Cross Gold Mine, Permit No. M-1977-410; TR-7 close out

RE: Cross Gold Mine, Permit No. M-1977-410, Technical Revision No. 7 (TR-07) Close Out

Project		Caribou Mine Technical Revision No.7			
Title		Topographic Exhibit Caribou Mine Adit Excavation			
	Project No.	0801		File No.	
	GIS:	JST	11/19/20	Scale As Shown	Rev 0
	Check:	JST	11/19/20	Map 1	
	Review:	JST	11/19/20

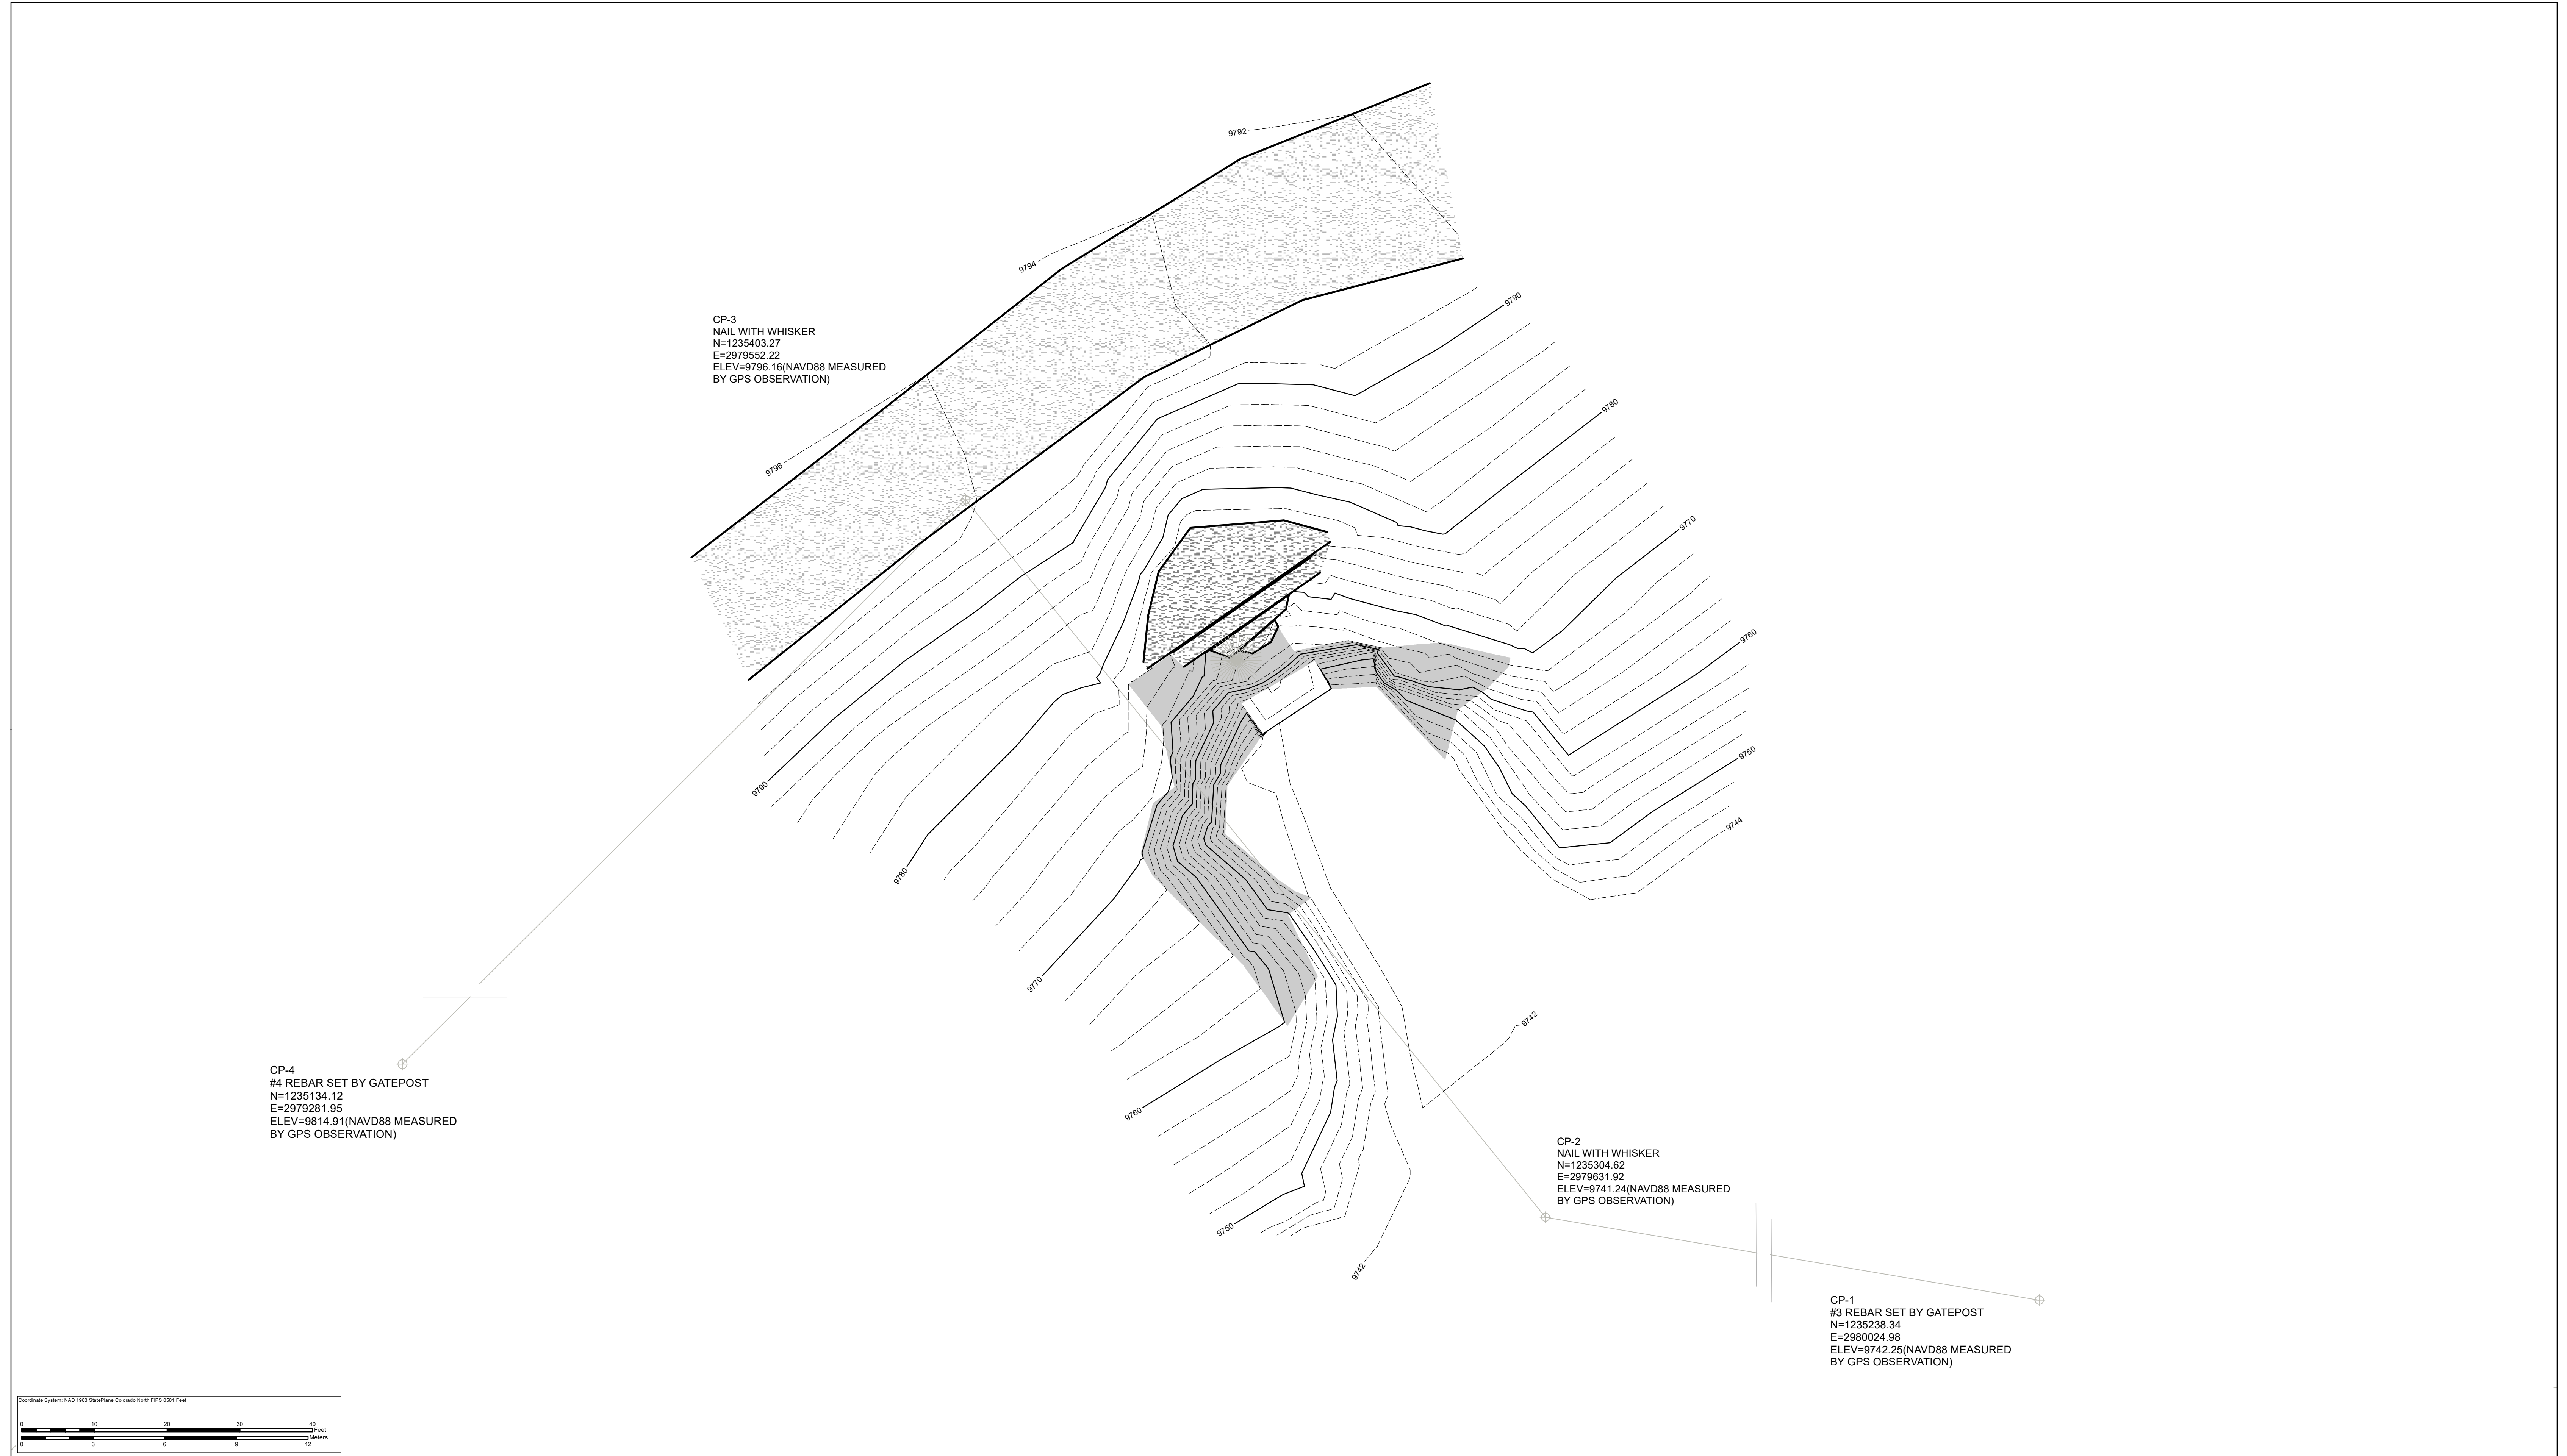
1. Provide a summary of the work completed to stabilize the "glory hole" and the slope face around the portal, including as-built information on the current slope geometry, cellular concrete and anchor placement, and the shotcrete placement.

2. The Division will not be able to approve TR-7 without an updated analysis that meets the minimum FOS requirements provided in the May 27, 2020 Memorandum from Peter Hays. Therefore, once the operator is able to collect and analyze the necessary data to provide a sufficient stability analysis for the portal slope, this revised analysis must be submitted to the Division through TR-7. Commit to submitting a Technical Revision to provide an engineering stability analysis for the proposed final slope configuration of the portal slope once the necessary information can be collected and analyzed.

The attached figure presents the current as-built configuration of the adit opening, adjacent wing walls, and slope above the portal up to the County Road. Included on this figure are the extent of shotcrete placement and surface exposure of the pervious cellular concrete

Field and laboratory testing of the various material encountered during this interim construction phase will be conducted to verify or update the material properties adopted in the analyses presented with TR-07. These data will be used in conjunction with the as-built slope geometry (see attached) to provide analyses which demonstrate that the slope meets the long-term slope stability requirements of MLRB policy.
